# PARTS & SERVICE NEWS

REF NO. AA04036

**SUBJECT:** PAYLOAD METER III™ SYSTEM RECORDING INCORRECT SPEEDS WHILE STOPPED

**PURPOSE:** Inform the field of a solution to prevent incorrect speed information being recorded in PLM III data.

FIGURE 1. INSTALLATION OF ATTENUATOR

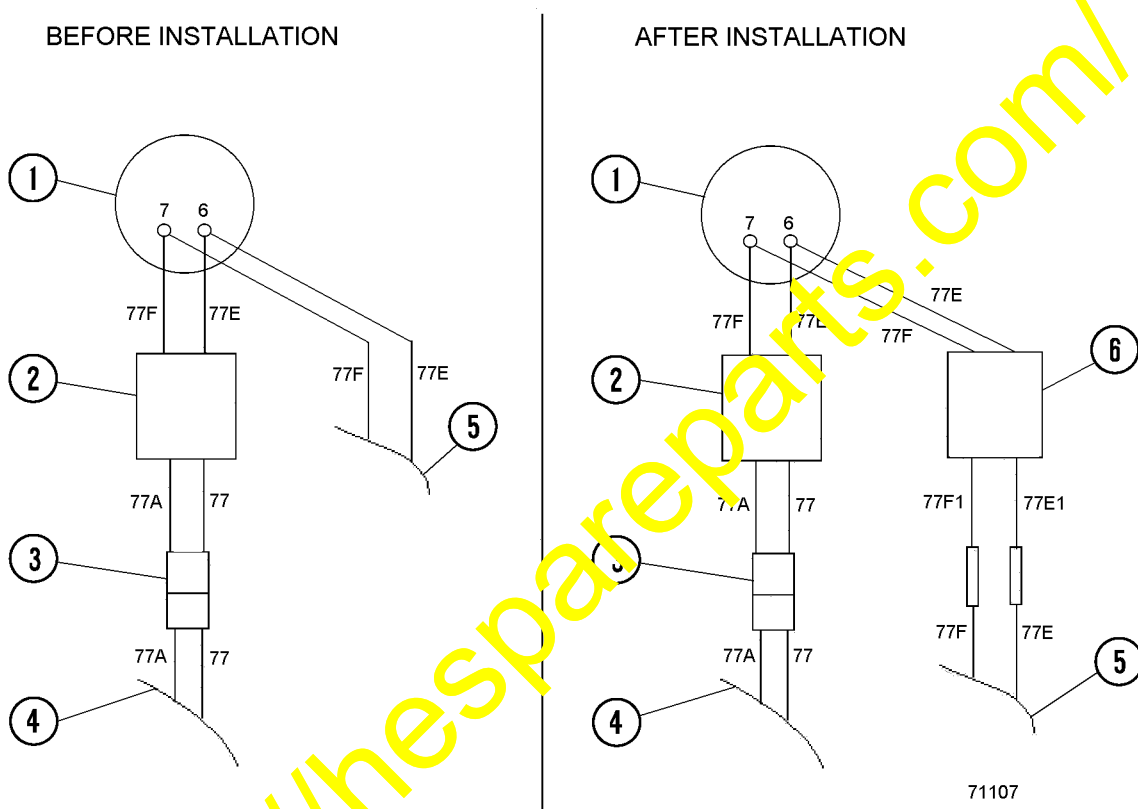
Some PLM III systems in the field may record incorrect speed data. The incorrect speeds are generated when the truck is stopped. To eliminate this problem, an attenuator (EK3046) can be added to the input circuit on the Payload Meter III system. Follow the instructions below for installing the attenuator (6, Figure 1) on the truck.

1. Access the terminals located on the back of the speedometer (1, Figure 1).
2. Remove ring terminal 77F on harness (5) attached to terminal 7 on speedometer (1). Notice that there are two ring terminals 77F on terminal 7 of the speedometer. The one that must be removed is on harness (5), and not the ring terminal connected to the two wire adapter harness (2).

3. Remove ring terminal 77E on harness (5) attached to terminal 6 on the speedometer. Notice that there are two ring terminals 77E on terminal 6 of the speedometer. The one that must be removed is on harness (5) and not the ring terminal connected to the two wire adapter harness (2).

4. After ring terminals 77E and 77F from harness (5) have been removed from the speedometer, the ring terminals must be cut off these two wires (leaving the two remaining wires as long as possible) and the wires should be stripped back to prepare it to be spliced to the attenuator (6) wire leads.
5. Insert the stripped wire 77E into the butt splice on the attenuator labeled 77E1. Crimp the splice.
6. Insert the stripped wire 77F into the butt splice on the attenuator labeled 77F1. Crimp the splice.
7. Connect the ring terminal on the attenuator labeled 77E to terminal 6 on the speedometer.
8. Connect the ring terminal on the attenuator labeled 77F to terminal 7 on the speedometer.
